Form 3160-5  
(June 2019)UNITED STATES  
DEPARTMENT OF THE INTERIOR  
BUREAU OF LAND MANAGEMENTFORM APPROVED  
OMB No. 1004-0137  
Expires: October 31, 2021**SUNDRY NOTICES AND REPORTS ON WELLS**  
**Do not use this form for proposals to drill or to re-enter an abandoned well. Use Form 3160-3 (APD) for such proposals.**

8. Well Name and No. MERCILESS 13 FED COM/204H

Merciless 13 Fed Com 513H (FKA 204H) API #: 30-025-50966

EOG respectfully requests an amendment to our approved APD for this well to reflect the following changes:

## WELL LOCATION AND ACREAGE DEDICATION PLAT

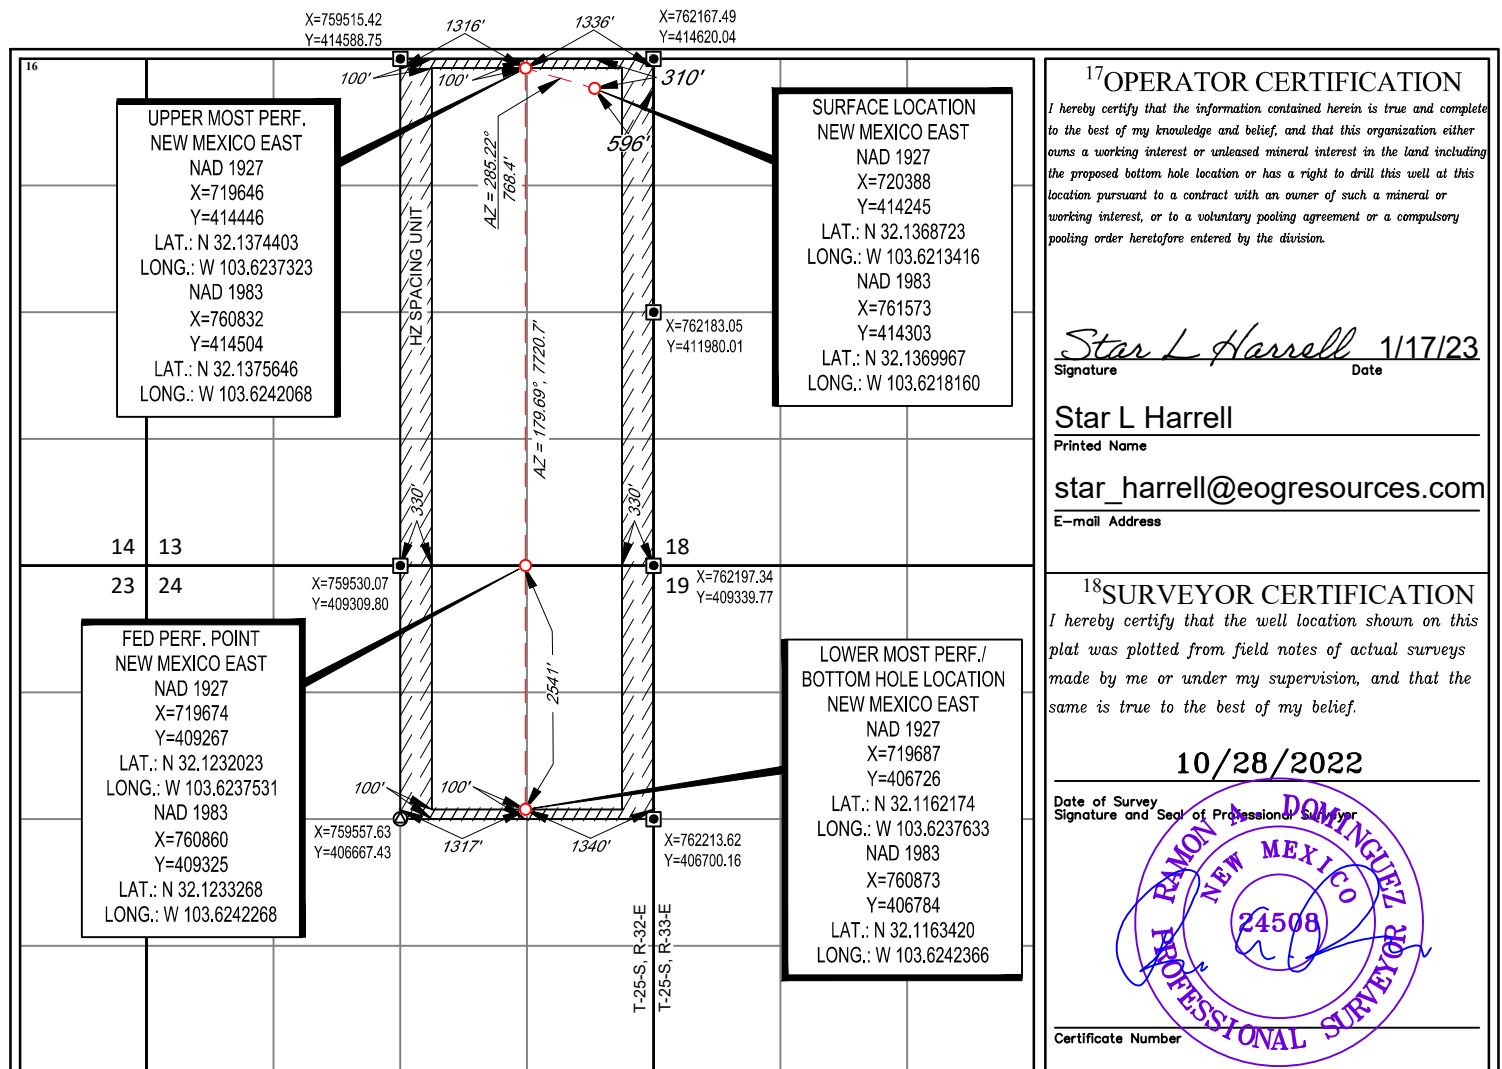
Change SHL from T-25-S, R-32-E, Sec 13, 504' FNL, 1482' FEL, Lea Co., NM, to T-25-S, R-32-E, Sec 13, 310' FNL, 596' FEL, Lea Co., N.M.

Change BHL from T-25-S, R-32-E, Sec 24, 2544' FNL, 1295' FEL, Lea Co., NM, to T-25-S, R-32-E, Sec 24, 2541' FNL, 1340' FEL, Lea Co., N.M.

| UL or lot no. | Section   | Township    | Range       | Lot Idn  | Feet from the | North/South line | Feet from the | East/West line | County     |
|---------------|-----------|-------------|-------------|----------|---------------|------------------|---------------|----------------|------------|
| <b>A</b>      | <b>13</b> | <b>25-S</b> | <b>32-E</b> | <b>-</b> | <b>310'</b>   | <b>NORTH</b>     | <b>596'</b>   | <b>EAST</b>    | <b>LEA</b> |

| UL or lot no. | Section   | Township    | Range       | Lot Idn  | Feet from the | North/South line | Feet from the | East/West line | County     |
|---------------|-----------|-------------|-------------|----------|---------------|------------------|---------------|----------------|------------|
| <b>G</b>      | <b>24</b> | <b>25-S</b> | <b>32-E</b> | <b>-</b> | <b>2541'</b>  | <b>NORTH</b>     | <b>1340'</b>  | <b>EAST</b>    | <b>LEA</b> |

# Design A

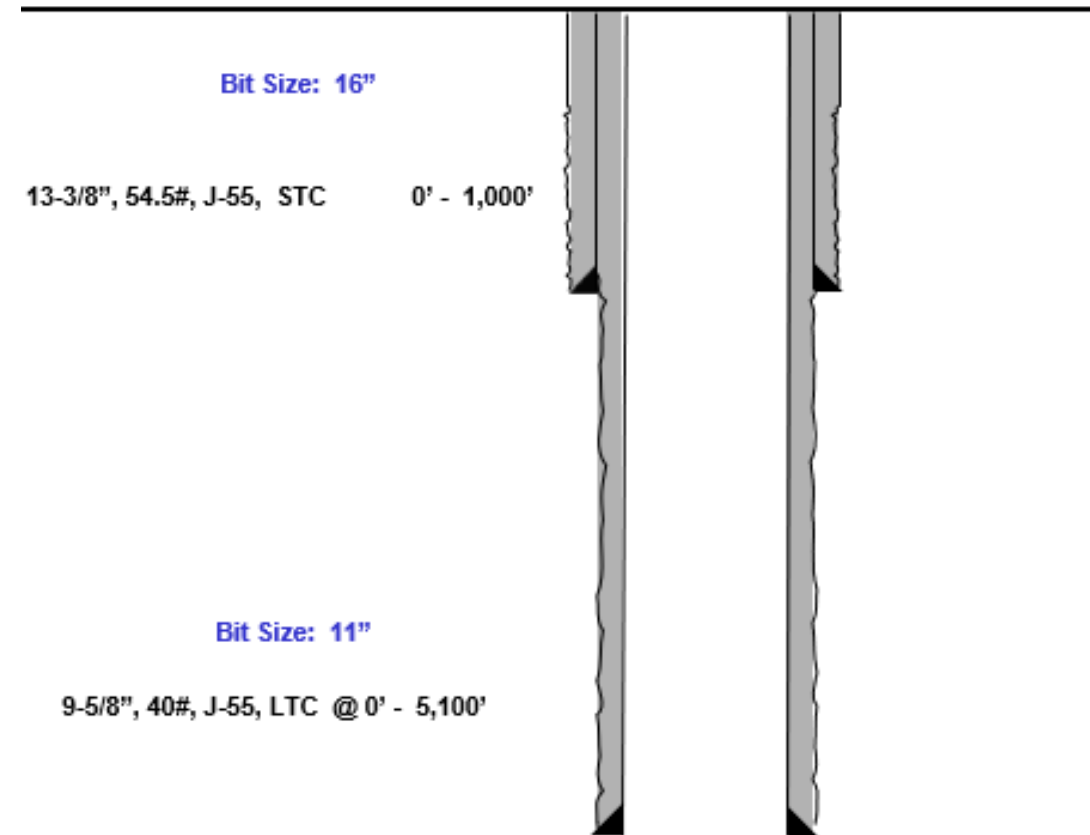
**EOG request permission to allow deviation from the 0.422" annulus clearance requirement for the intermediate (salt) section from Onshore Order #2 under the following conditions:**

- The variance is not applicable within the Potash Boundaries or Capitan Reef areas.
- Operator takes responsibility to get casing to set point in the event that the clearance causes stuck pipe issues

- 11" Bit + 0.52" Average hole enlargement = 11.52" Hole Size
  - 0.9475" Clearance to casing OD

$$= \frac{11.52 - 9.625}{2}$$
  - 0.4475" Clearance to coupling OD
